IEEE 802.3da SPMD TF - 802.3da & Precision Time Protocol: 802.3da & Precision Time Protocol

Peter Jones - Cisco

Comment #90 Suggested Remedy - *Updated*

Figure 148-2—PLCA functions within the Reconciliation Sublayer (RS)

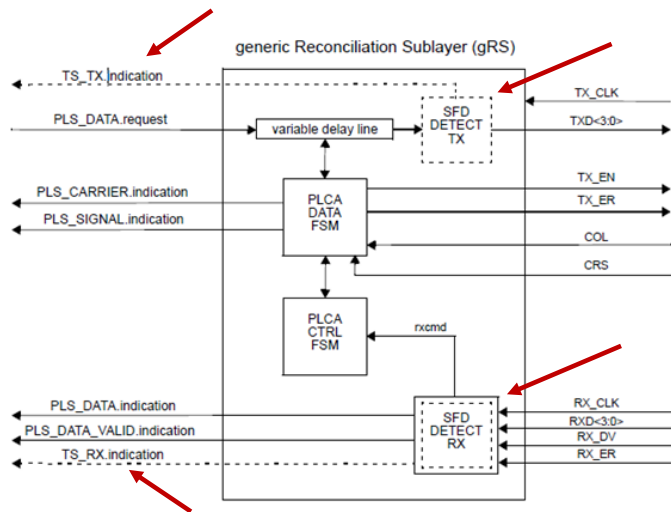
Comment #91 Suggested Remedy - *Updated*

Modify "Figure 148-2--PLCA functions within the Reconciliation Sublayer (RS)" to add *TS_TX.indication*, *TS_RX.indication*, *SFD DETECT TX* and *SFD DETECT RX* as shown in 802.3cg 2019 D2.0 Figure 148-2.

Insert the following subclause before "148.4.2 Mapping of MII signals to PLS service primitives and PLCA functions"

Operation with TSSI

When TSSI is supported, transmit SFD detection occurs after the PLCA variable delay line, as shown in Figure 148-2.

*Clause 90 defines *TS_TX.indication* (90.4.3.1) and *TS_RX.indication* (90.4.3.2). Clause 90 also defines *TS_SFD_Detect_TX* (90.5.1) and *TS_SFD_Detect_RX* (90.5.2), these are shown in Figure 148-2 as *SFD DETECT TX* and *SFD DETECT RX* respectively.*
